Maules Creek State Significant Development Continuation Project - 2025.

8th August 2025

I object to this Continuation Project – it should not be approved.

Sunday 23rd February 2025 – Gravel pit LFR.

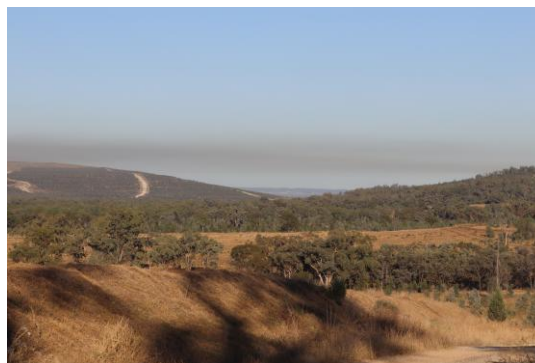
The following photos were taken at the gate of the Shire Gravel Pit on the Leard Forest Road and clearly show the 'cloud' of dust coming from the Maules Creek Mine Site. Lack of dust suppression perhaps?

Monday 24th February 2025 – Gravel Pit LFR.

Air Quality - Friday, 14 April 2023, 5:29:22 PM (same property)

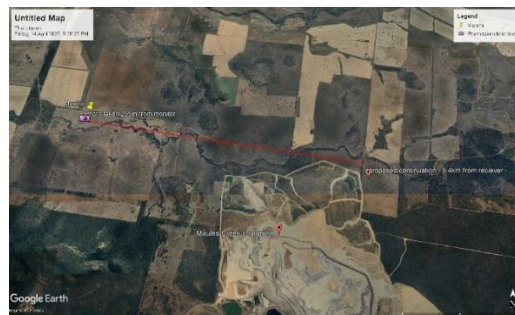
This site is not used for environmental monitoring, it is for operational monitoring and no matter how many times this mine has shaken my house or covered my garden with the fallout from blasting which prevents me from having a vegetable garden, it appears that the 'monitoring' from this (?) monitor always determines there are no 'exceedance's' at this receiver....

(disclosure – yes, this property does have acquisition rights, but only for noise, NOT DUST!)

Photo taken approximately 255m south of the 'Environmental Monitor' (photo above) as indicated in this google earth map below.

Figure 65a: Impacts Requiring Offsets –
SAS Envelope

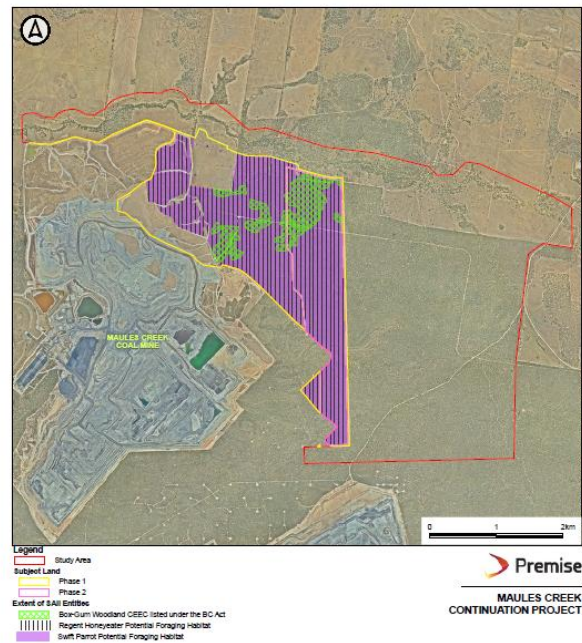
No mention of clearing of habitat by mining companies!

Map showing potential Foraging habitat for Swift Parrots

Figure 38a

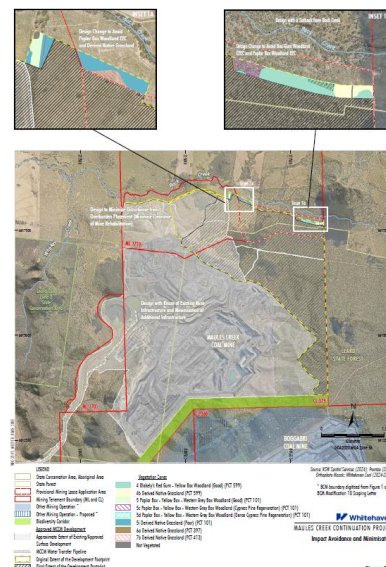
The Black area (Go-line) must not be permitted in this area near Back Creek.
